**Flood Risk Assessment and Drainage Strategy Addendum
For the Resubmission of the Proposed Inland Waterways Marina Scheme
Previously Submitted Under Planning Application 18/00904/F
At Glebe Farm, Claydon, Banbury, OX17 1TD**

2420 – FRA & DS Addendum – Aug 2020

Job Title
**PROPOSED MARINA AT
 BODDINGTON ROAD, CLAYDON,
 BANBURY**

Drawing Title PROPOSED SITE PLAN	Drawing Number A05/020	1
--	----------------------------------	---

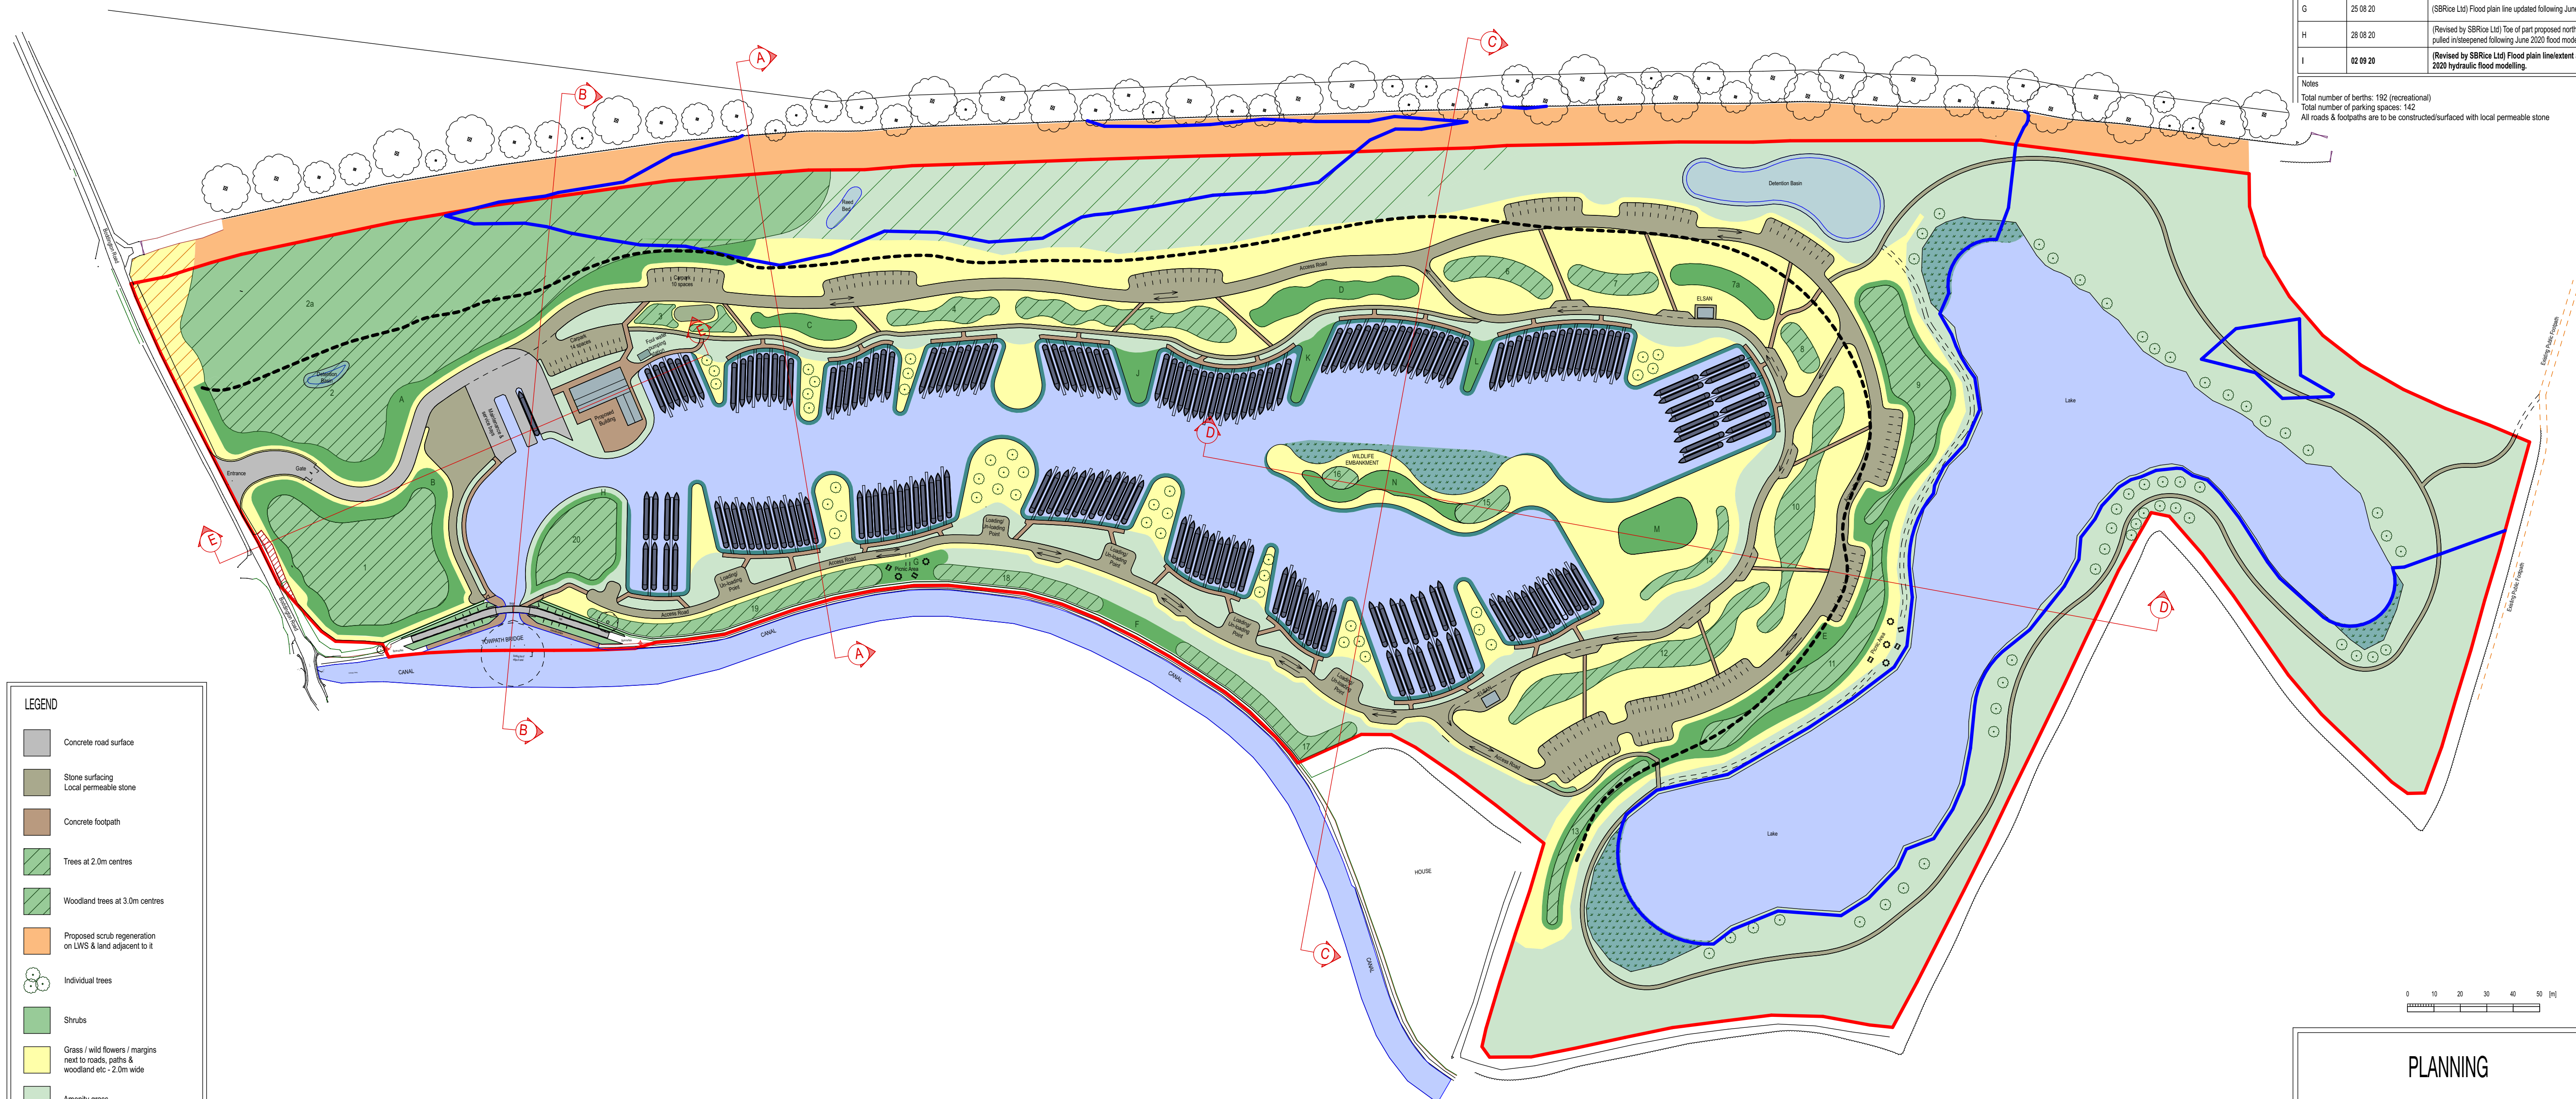
- 3.6 The proposed layout provided in Appendix 3 for clarity shows the modelled 1 in 100 year plus 35% climate change flood line alongside the line at which the proposed embankments return to existing ground levels and clearly demonstrates that the embankments do not extend into this flood plain at all.

Revisions		
Rev. No.	Date	Revision
A	07.11.18	Revised Planning Issue.
B	21.01.19	Scale amended to 1:1250. Footpaths revised.
C	28.01.19	Minor amendments to notes.
D	29.05.19	Revised site access road. Proposed works in flood zone relocated.
E	01.07.19	Revised landscaping & annotation.
F	15.07.19	Revised landscaping & annotation.
G	25.08.20	(SBRice Ltd) Flood plain line updated following June 2020 flood modelling.
H	28.08.20	(Revised by SBRice Ltd) Toe of part proposed northern marina embankment pulled inwards following June 2020 flood modelling.
I	02.09.20	(Revised by SBRice Ltd) Flood plain line/extent amended following August 2020 hydraulic flood modelling.

Drawing Title	Drawing Number
PROPOSED SITE PLAN	A05/022 H

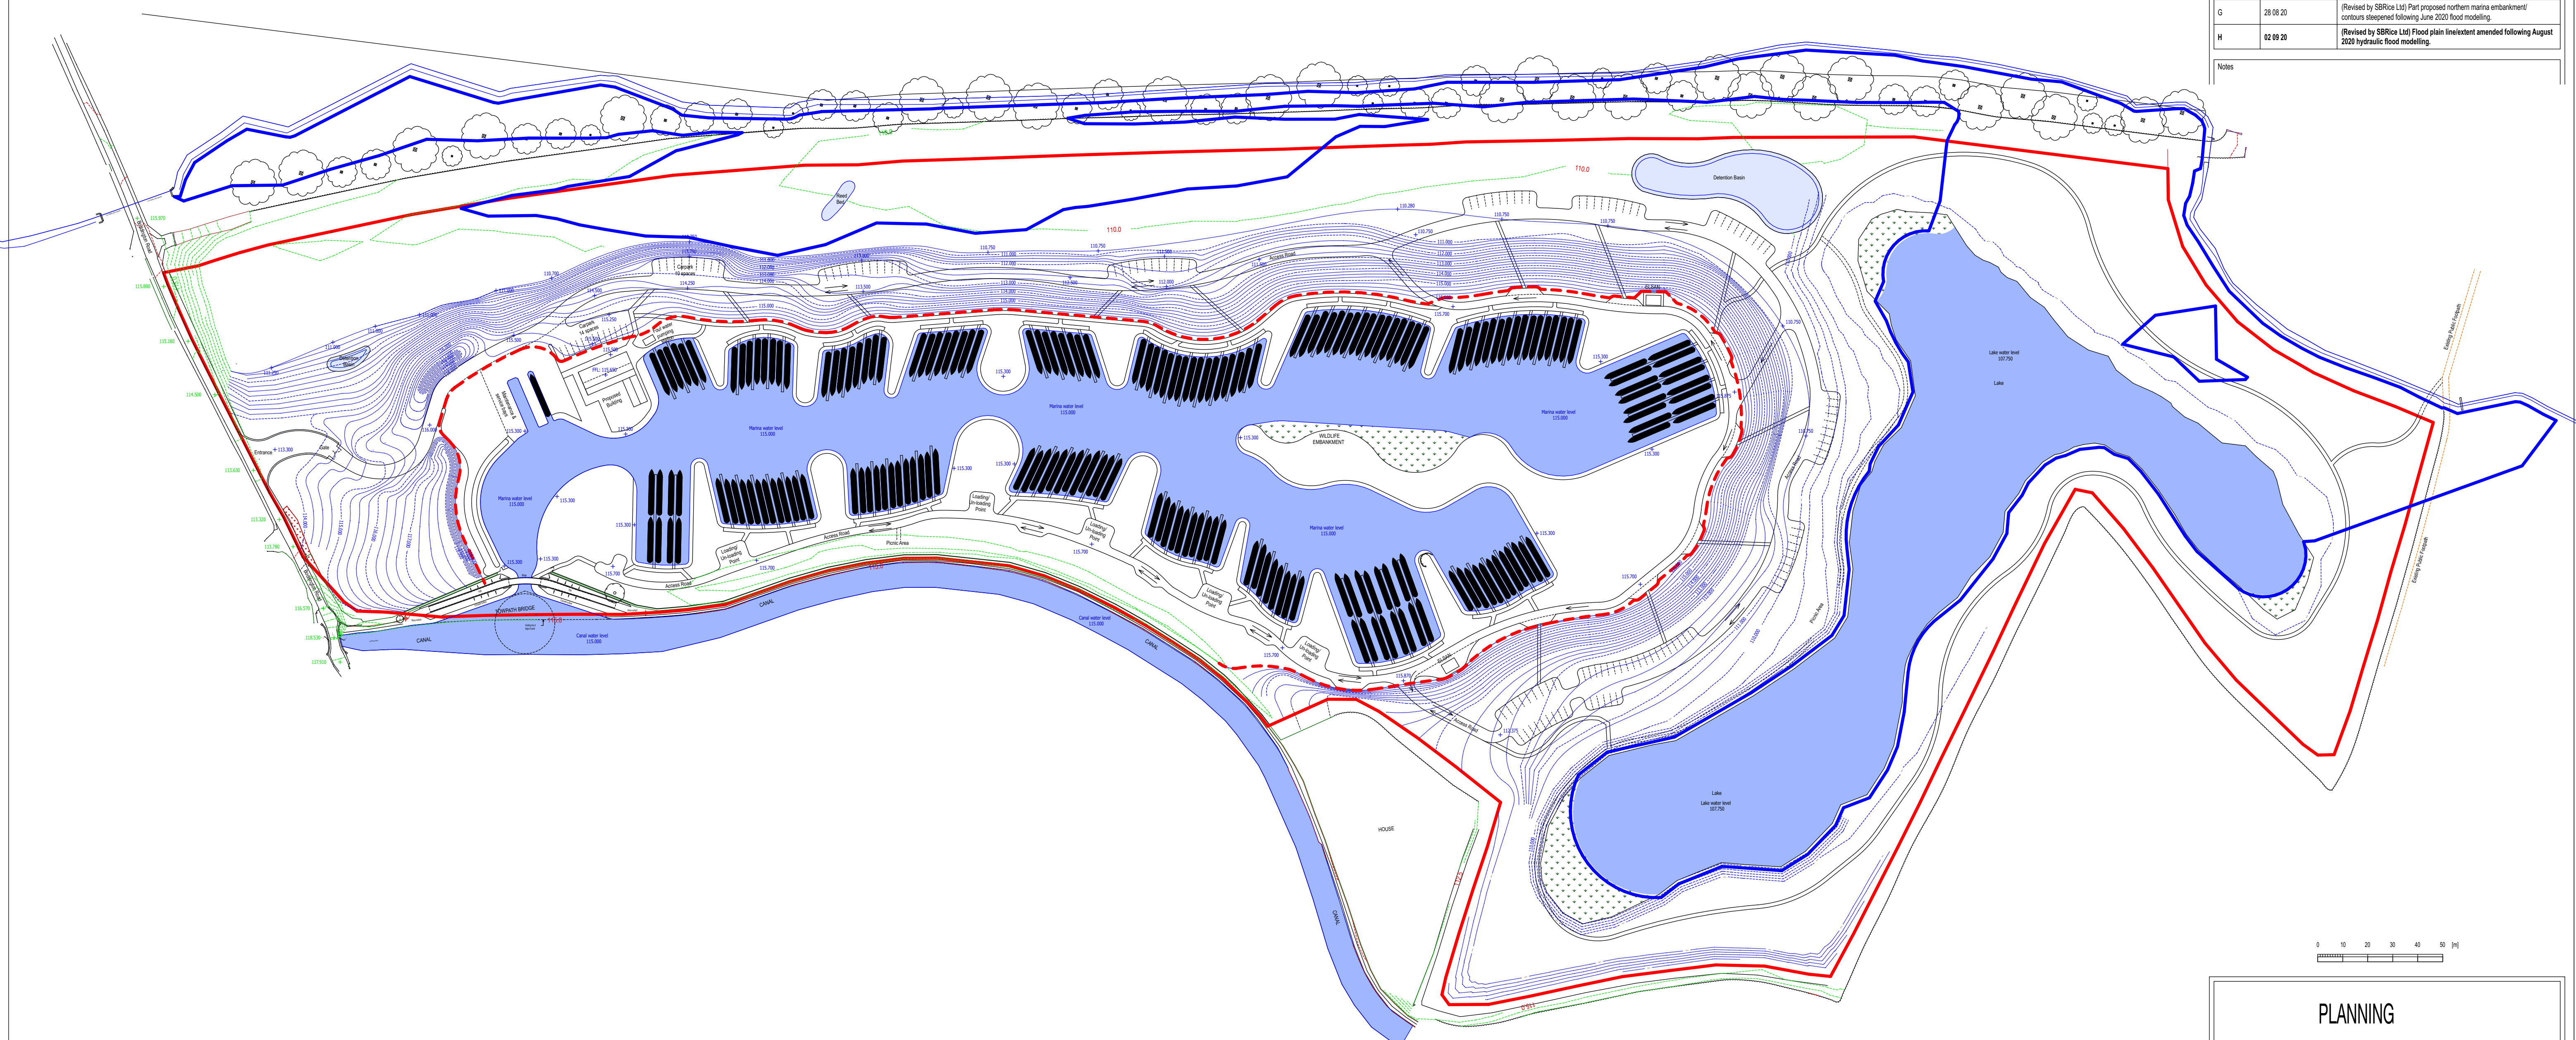
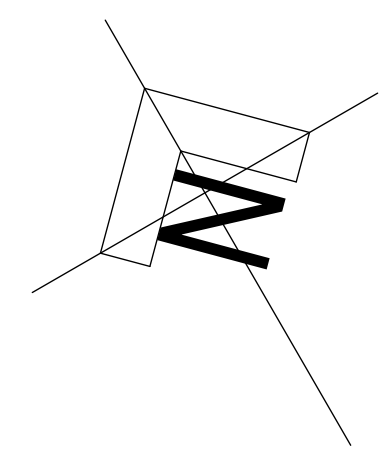
Rev. No.	Date	Revision
A	07 11 18	Revised Planning Issue.
B	21 01 19	Scale amended to 1:1250. Footpaths revised.
C	30 01 19	Minor amendments.
D	11 07 19	Levels & contours amended to Plan A05-020E.
E	15 07 19	Minor amendments to levels & contours.
F	25 08 20	(SBRice) Flood plain line amended following modelling.
G	28 08 20	(Revised by SBRice Ltd) Part proposed northern marina embankment/ contours steepened following June 2020 flood modelling.
H	02 09 20	(Revised by SBRice Ltd) Flood plain line/extent amended following August 2020 hydraulic flood modelling.

Drawing Title: **SITE / MARINA
SECTIONS**
Drawing Number: **A05/100**

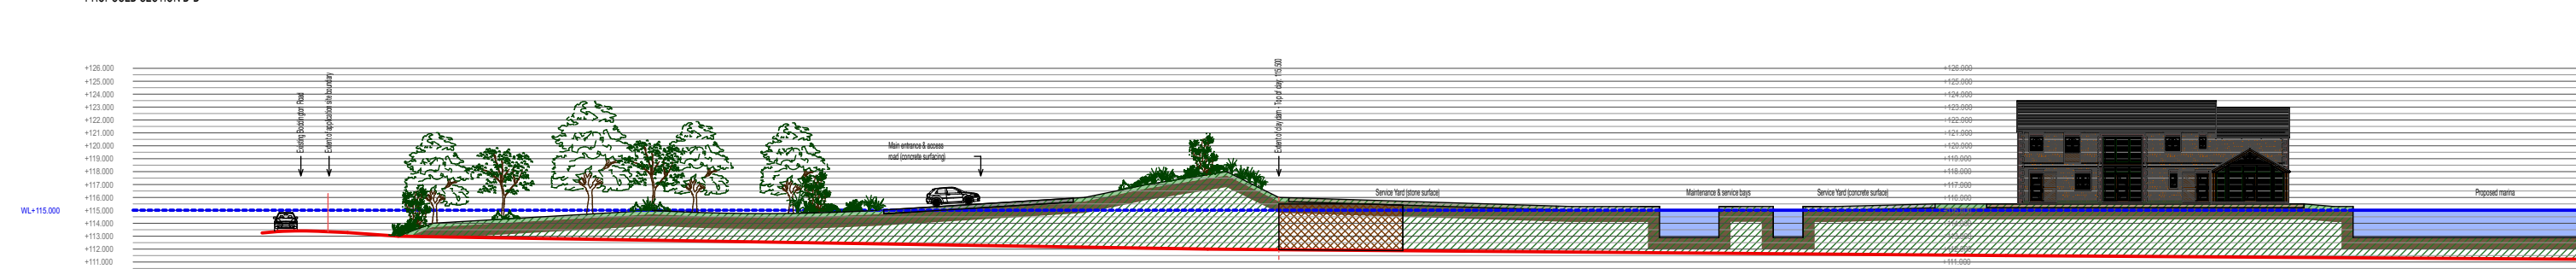
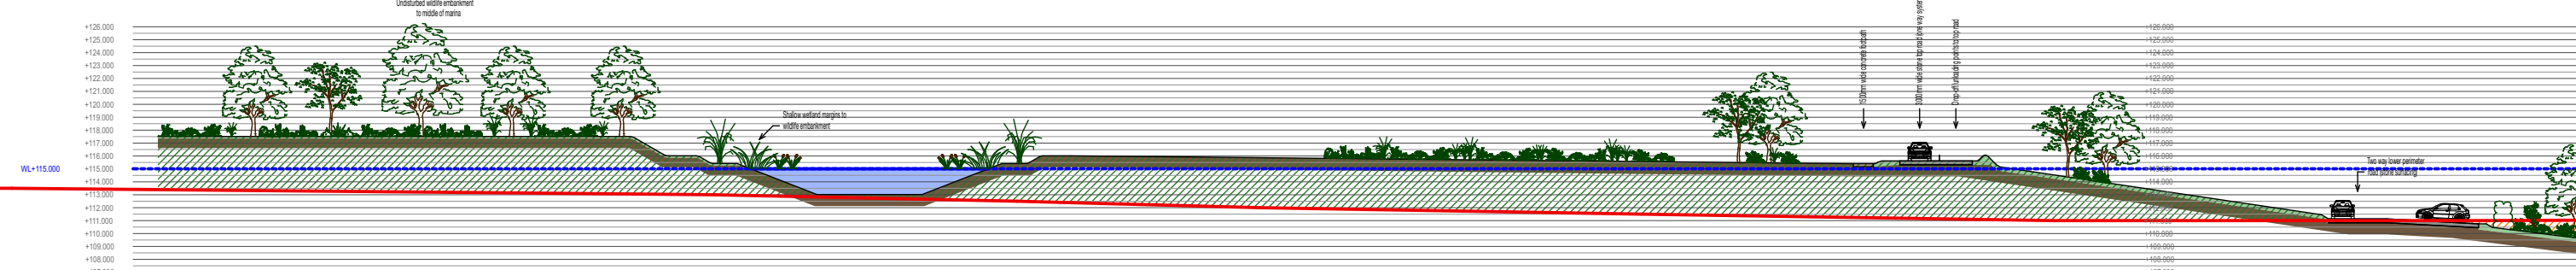
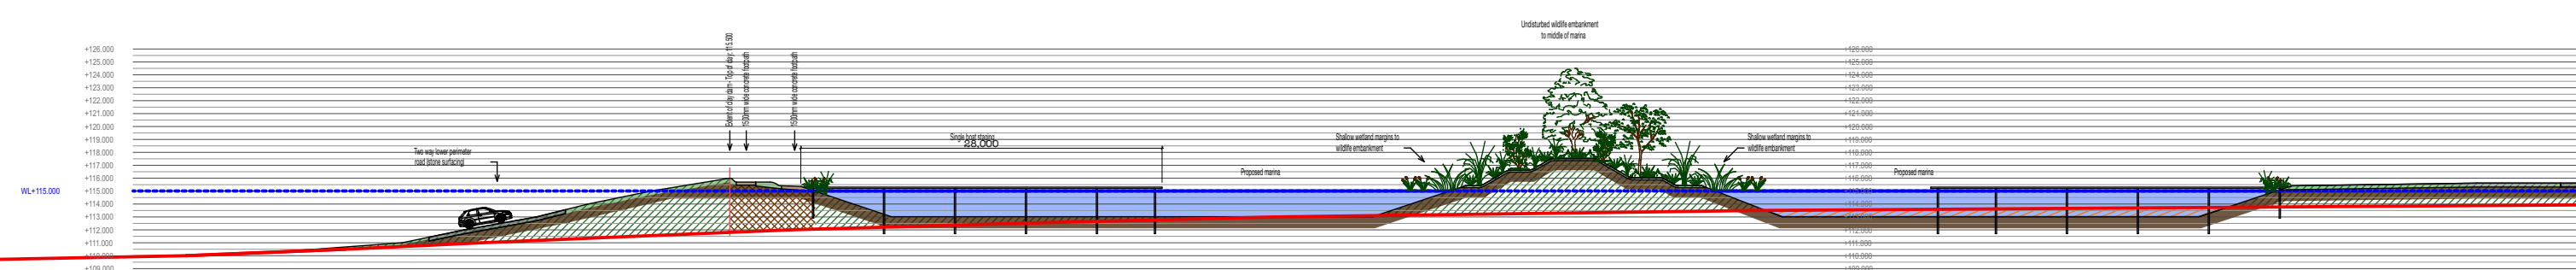
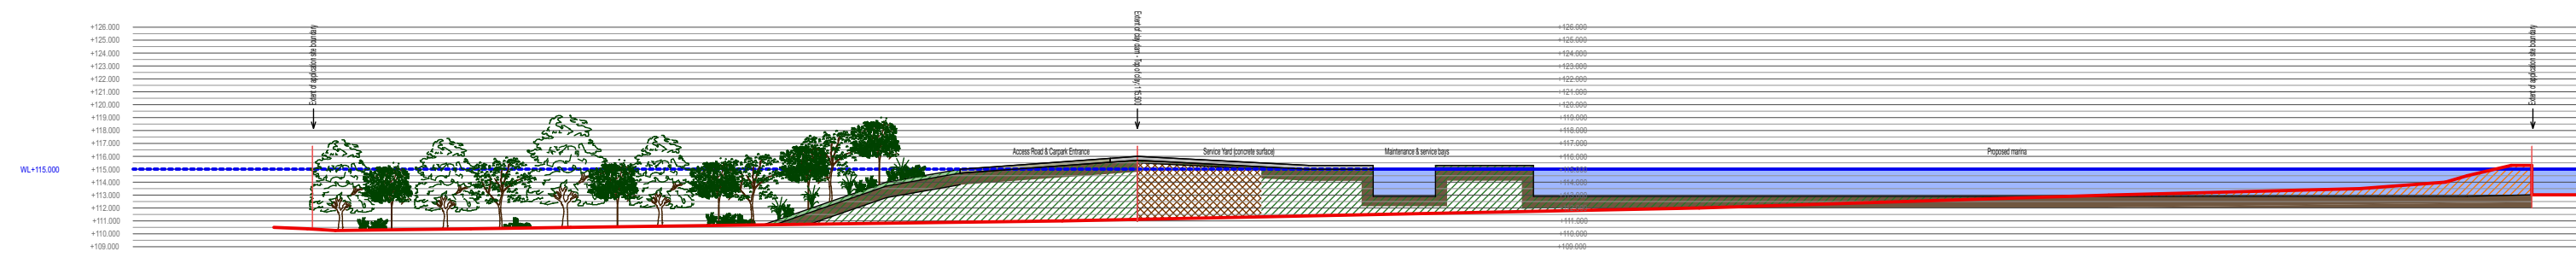
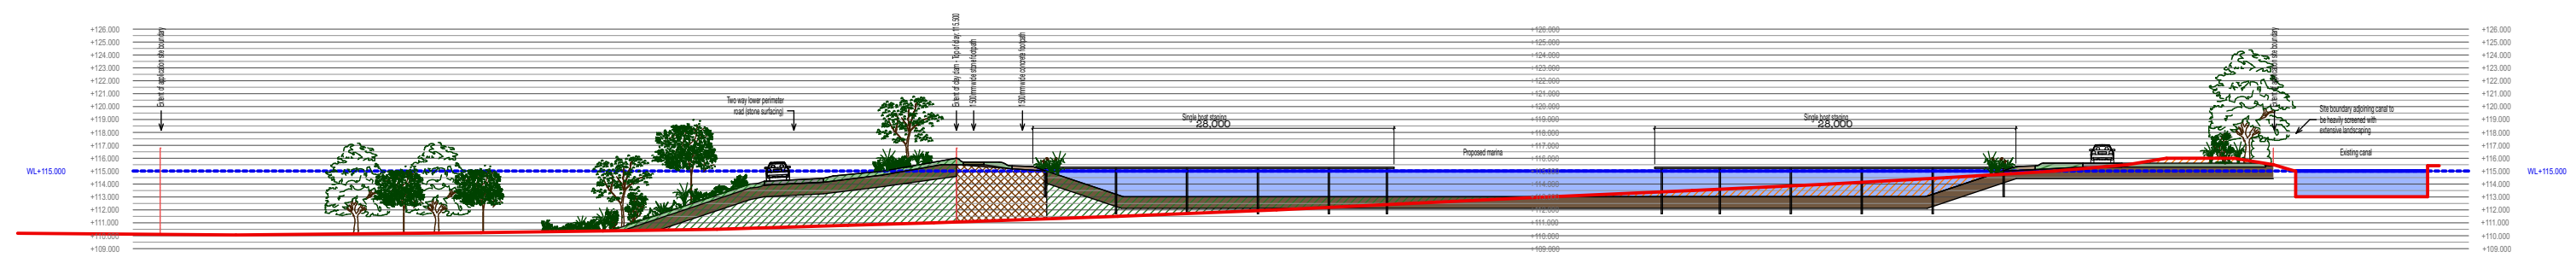
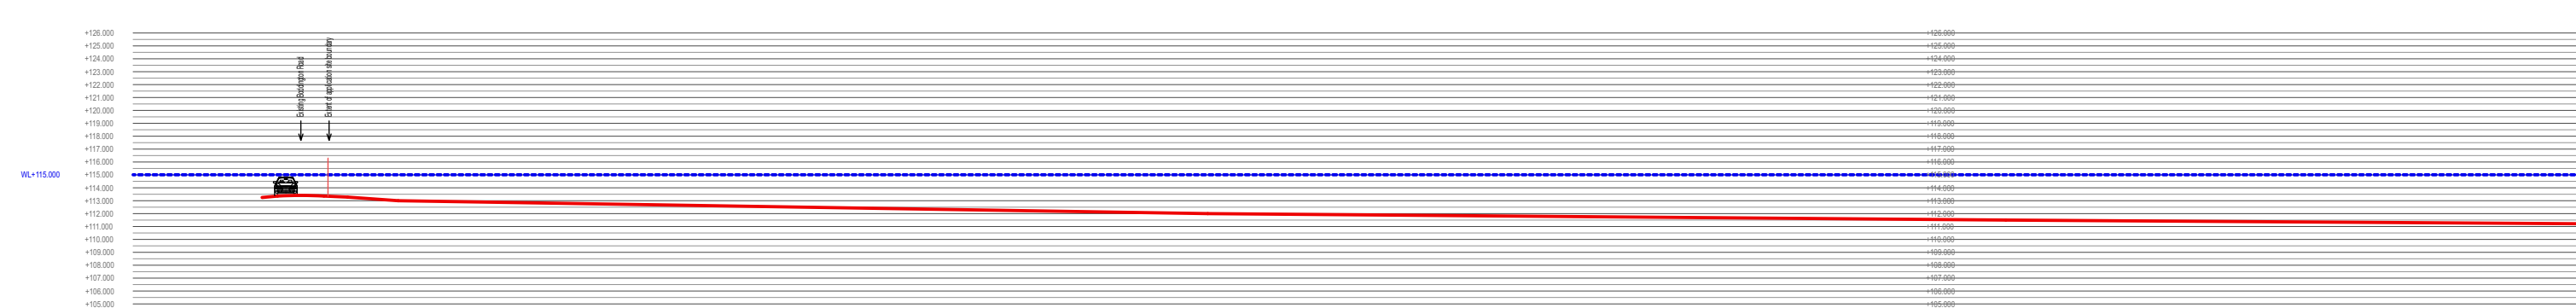
Rev. No.	Date	Revision
A	14 12 17	Vegetation amended to suit plans.
B	17 04 18	Sections updated to Proposed Site Plan A05-010G.
C	03 10 18	Sections updated to Proposed Site Plan A05-020.
D	29 01 19	Updated to Proposed Site Plan A05-020C & Building A05-405B.
E	17 07 19	Updated to Proposed Site Plan A05-020F.
F	19 07 19	Landscaping added to sections & Section B - B handed.
G	24 08 20	(SBRice Ltd) Proposed lake water level revised following flood modelling.
H	28 08 20	(Revised by SBRice Ltd) Proposed marina embankments steepened on sections AA & BB following June 2020 flood modelling.
I	02 09 20	(Revised by SBRice Ltd) Minor amendments following August 2020 updated hydraulic flood modelling.
